Application No: A.17-10-002
Exhibit No.: _____
Witness: David Mercer

Application of Southern California Gas Company
(U 904 G) and San Diego Gas & Electric Company
(U 902 G) Regarding Feasibility of Incorporating
Advanced Meter Data Into the Core Balancing
Process.

REBUTTAL TESTIMONY OF
DAVID MERCER
ON BEHALF OF
SOUTHERN CALIFORNIA GAS COMPANY AND
SAN DIEGO GAS & ELECTRIC COMPANY

August 10, 2018

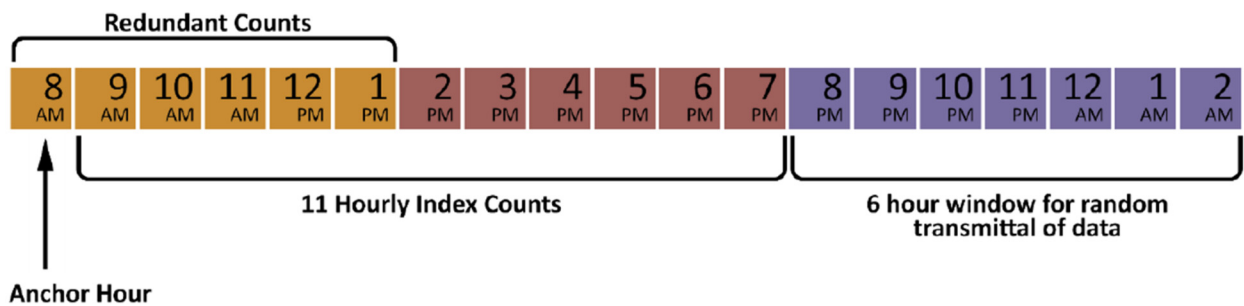
9 SCGC/IS includes a discussion of anchor reads that is based on information provided by
 10 SoCalGas in another proceeding, and although the statements remain logically accurate, the
 11 timing of the anchor read itself should be clarified. SCGC/IS depicts the anchor read as the *first*
 12 read of the MTU transmission as follows:⁶

13 However, the anchor read is actually the *last* read of the data transmission packet. The SCGC/IS
 14 depiction of the anchor read for the fourth send of the S3 transmittal schedule should be
 15 corrected to reflect that the 8 PM hour as the anchor read. A clarified graphical depiction of the
 16 S3 data transmission for 8PM is shown in Figure II-1.
 17

Figure II-2 – Clarified S4 Data Transmission

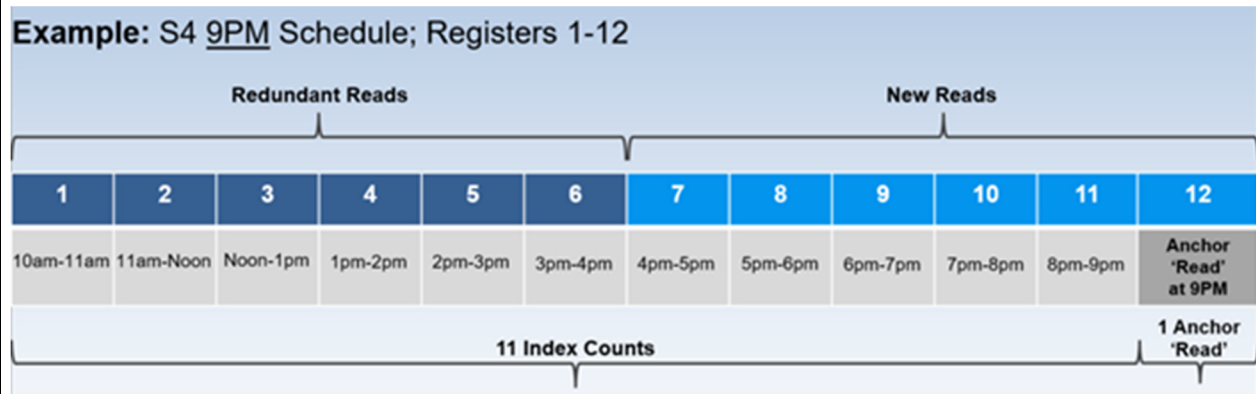
Similarly, SCGC/IS describes the S4 transmittal schedule as having the anchor read at 9am, but as described above, the anchor read is the last read in the MTU transmission and is 9 PM.⁷ A clarified graphical depiction of the S4 data transmission for 9PM is shown in Figure II-2.
